ADDENDUM TO THE CONTRACT

for the
Downtown Street Improvements – Phase I
Contract No. BE17-137

ADDENDUM NO.: ONE

DATE ADDENDUM ISSUED: November 18, 2016

7
-
NTS
SIDEWALK DEMOLITION AT RETAINING WALL

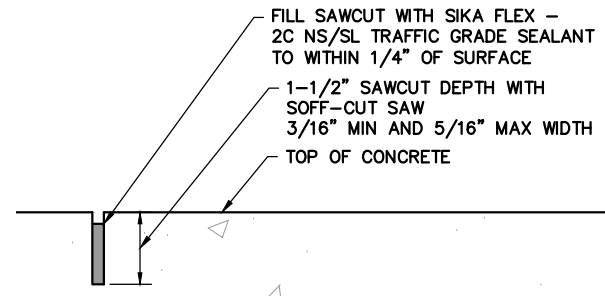
- Revision of the note regarding coordination of private work in detail 3
- Addition of note 2 to detail 7
- Addition of detail 8

- NOTES:**
1. THE EXACT LOCATION OF EXISTING RETAINING WALLS IN RELATION TO THE BUILDING FACE MAY VARY.
 2. CENTER 12-INCH LONG No.4 BAR AT 18-INCHES O.C. ALONG FRONT FACE OF RETAINING WALLS AT MID-DEPTH OF THE NEW SIDEWALK.

PAINTED TRAFFIC MARKINGS AND SIGN LAYOUT
BOP TO STA "S" 12+50

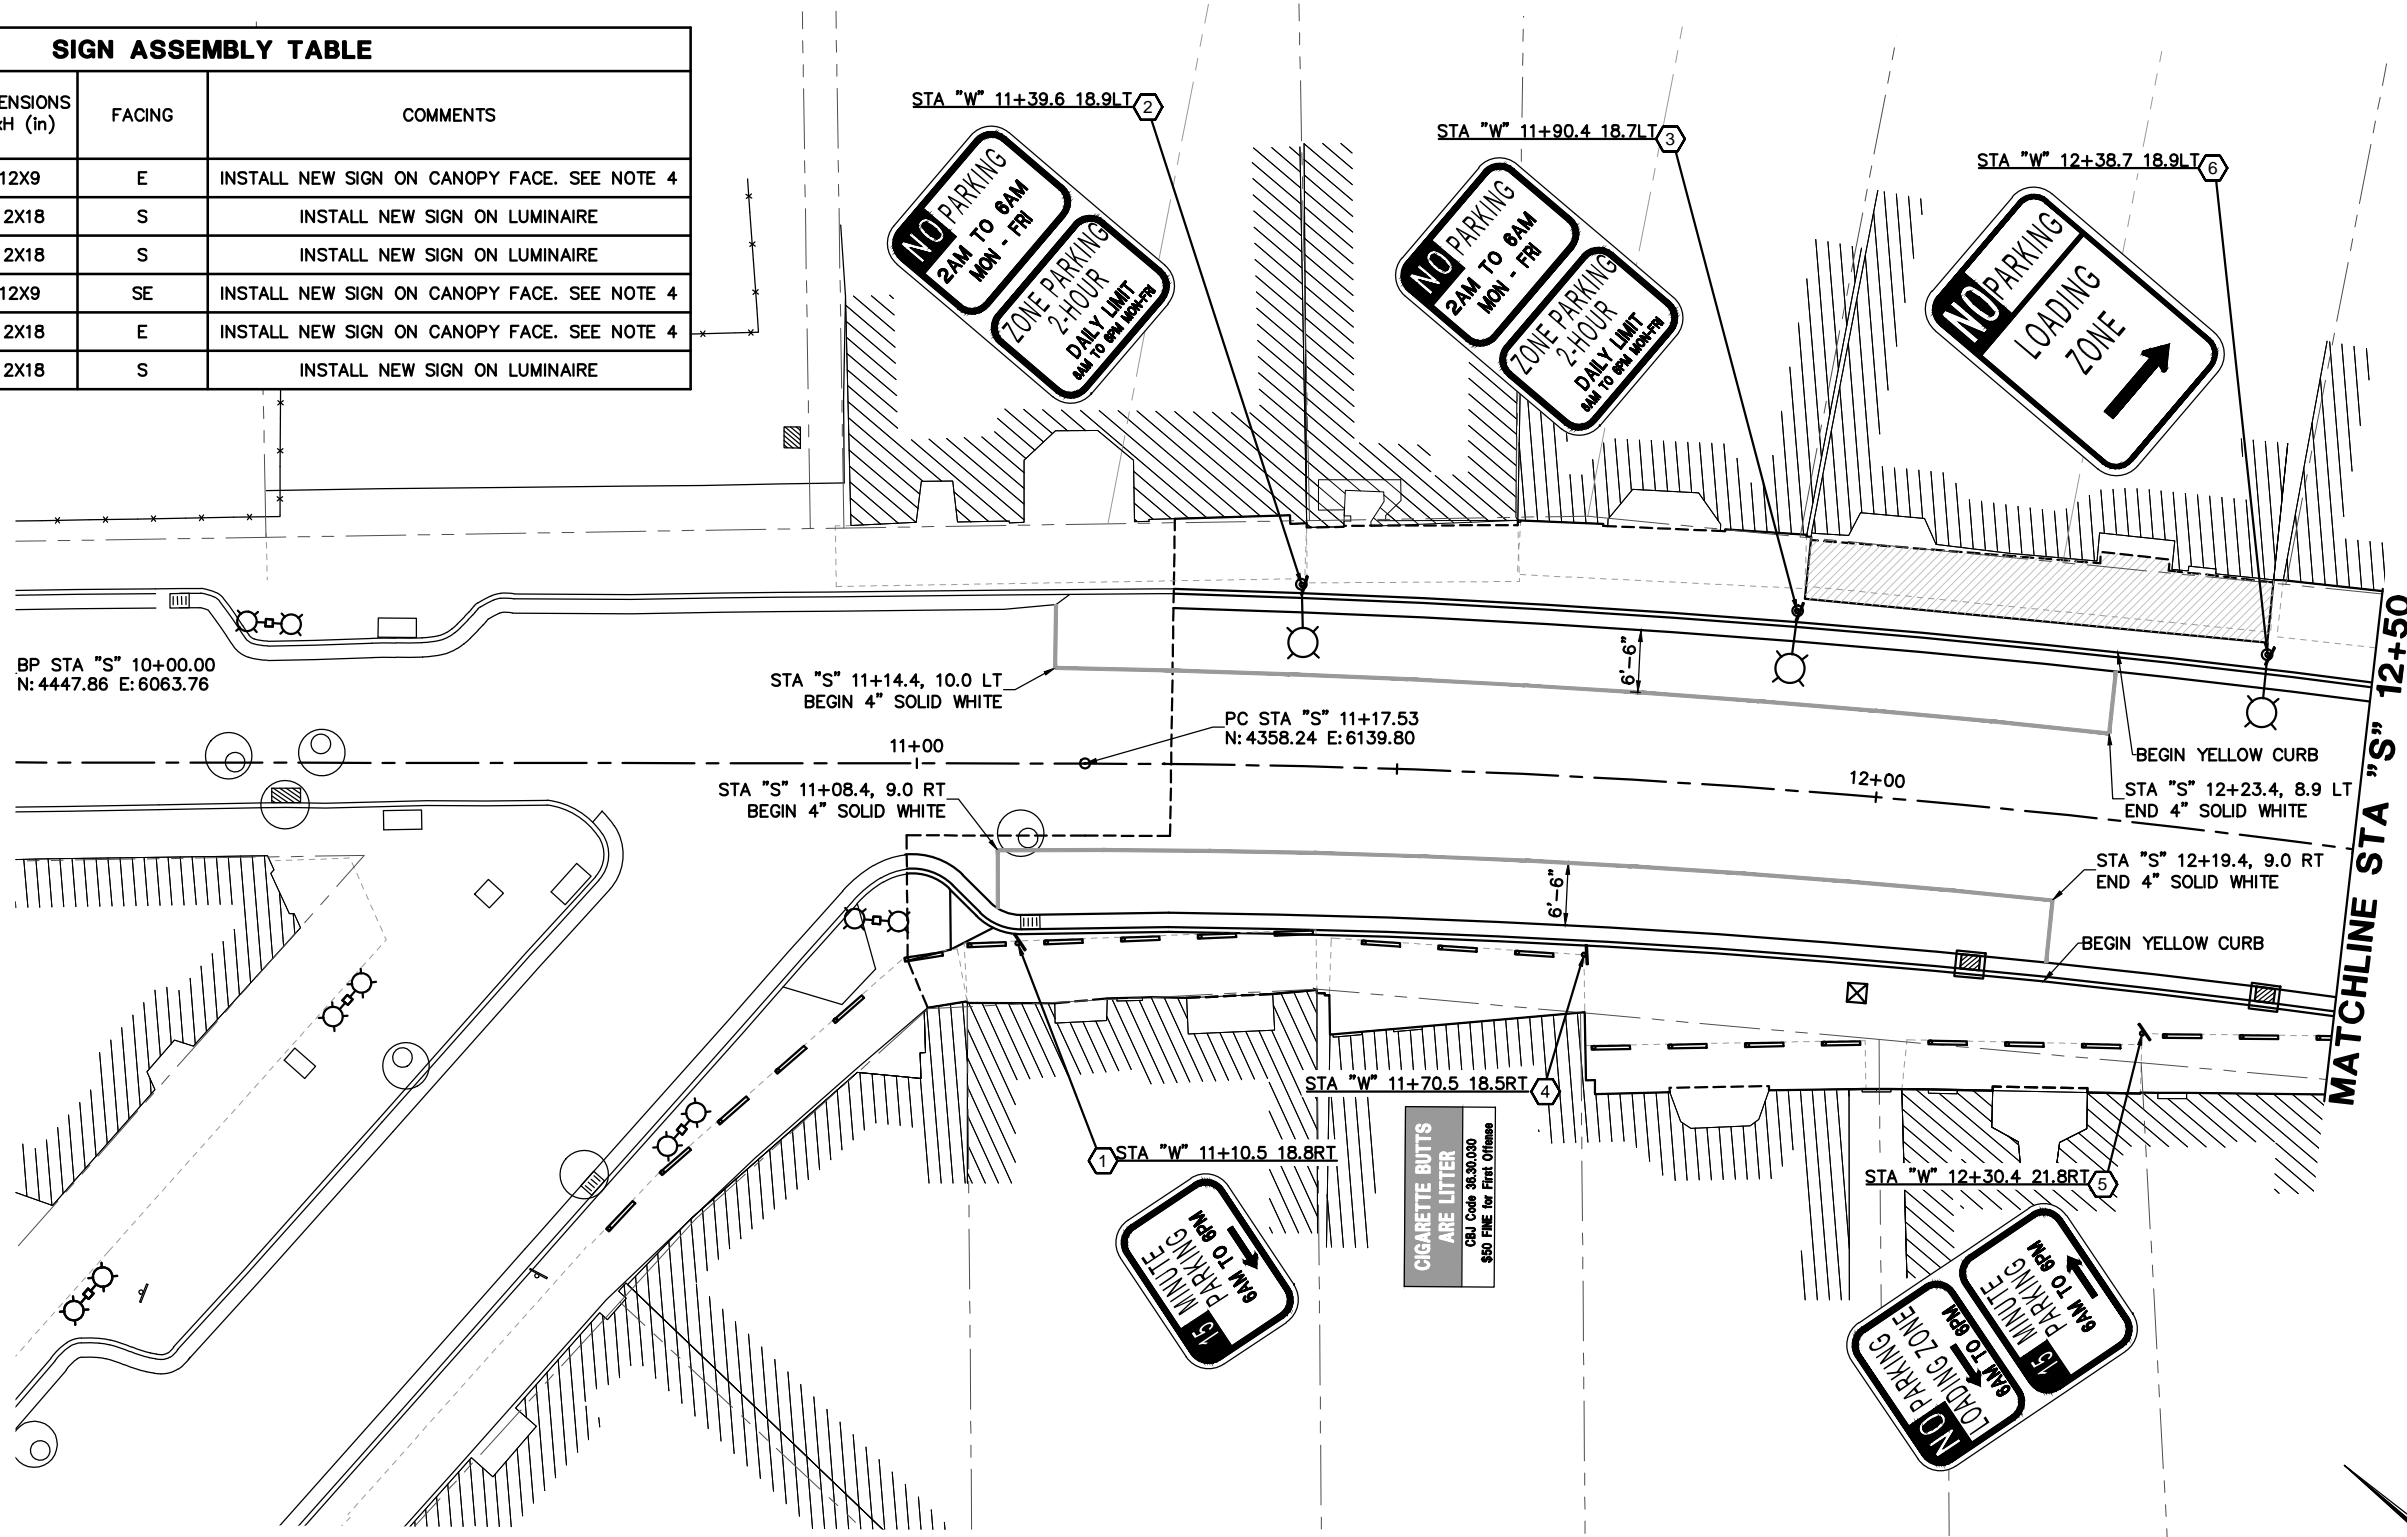
Changes to sheets 9 through 12 reduce the lineal footage of painted yellow curb.

HORIZONTAL AND VERTICAL CONTROL CURB AND GUTTER LAYOUT AND GRADES
STA "S" 17+50 TO EOP

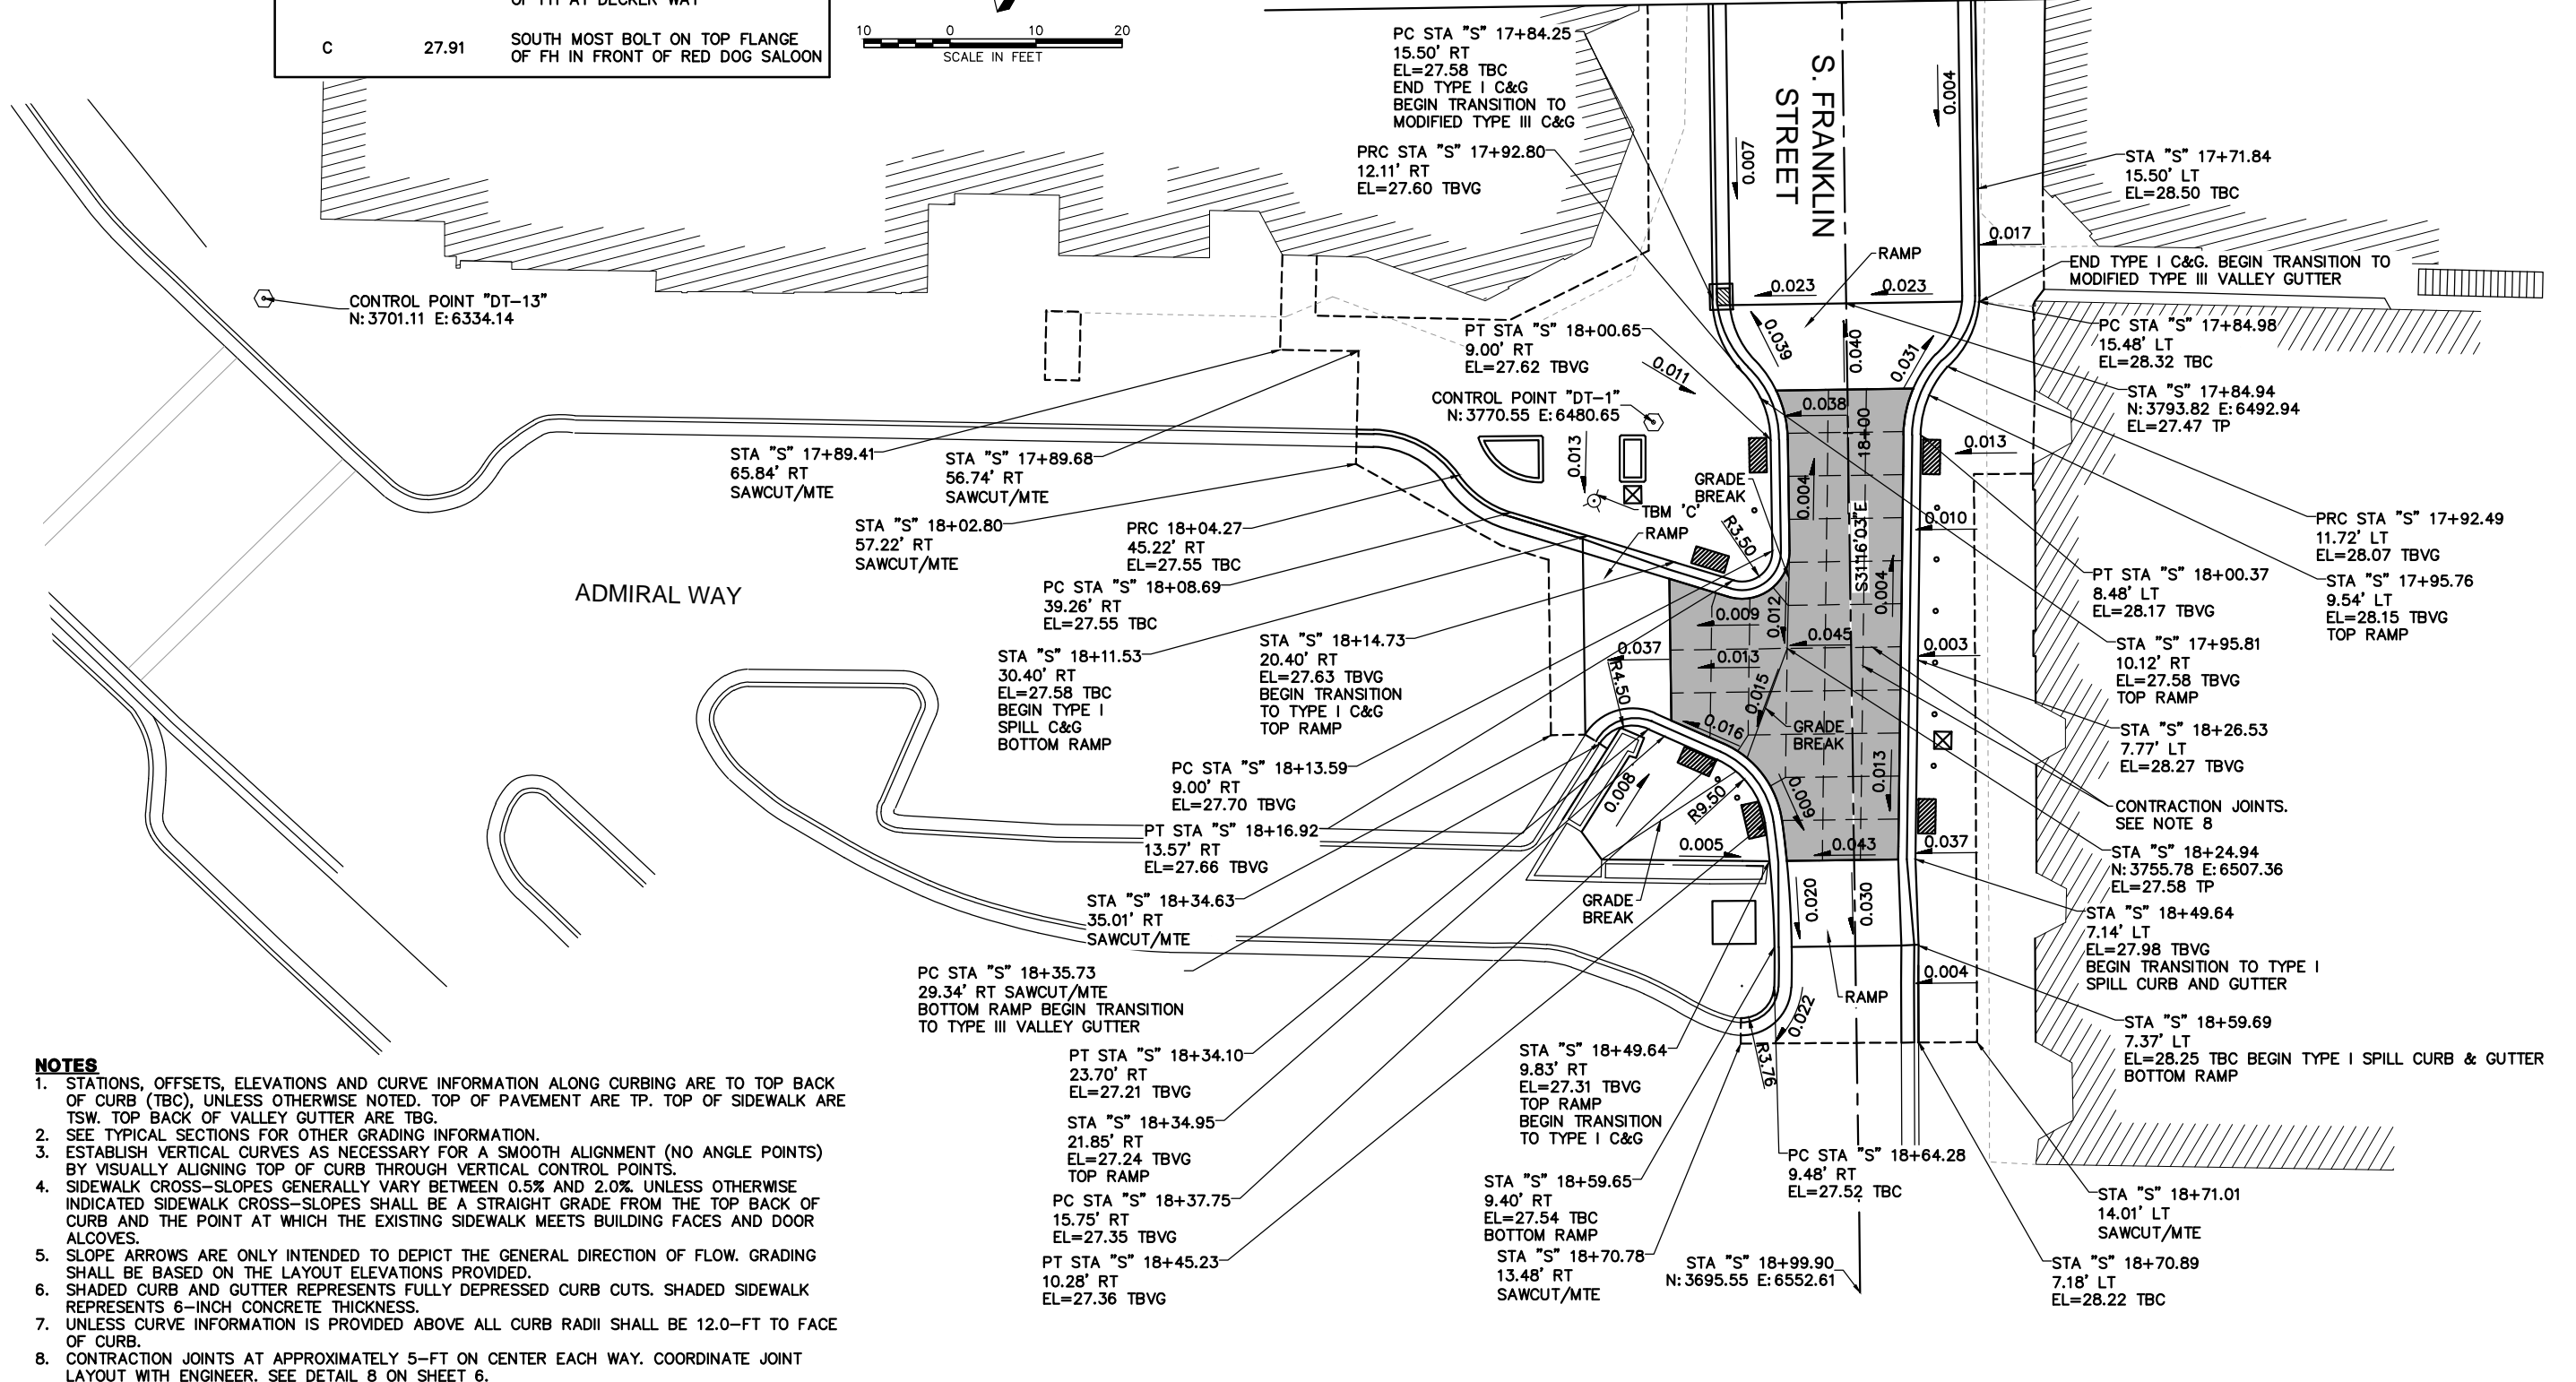
The only changes to sheet 16 are the addition of contraction joints within the raised intersection and the associated note 8.

- UNLESS CURVE INFORMATION IS PROVIDED ABOVE ALL CURB RADII SHALL BE 12.0-FT TO FACE OF CURB.
- CONTRACTION JOINTS AT APPROXIMATELY 5-FT ON CENTER EACH WAY. COORDINATE JOINT LAYOUT WITH ENGINEER. SEE DETAIL 8 ON SHEET 6.
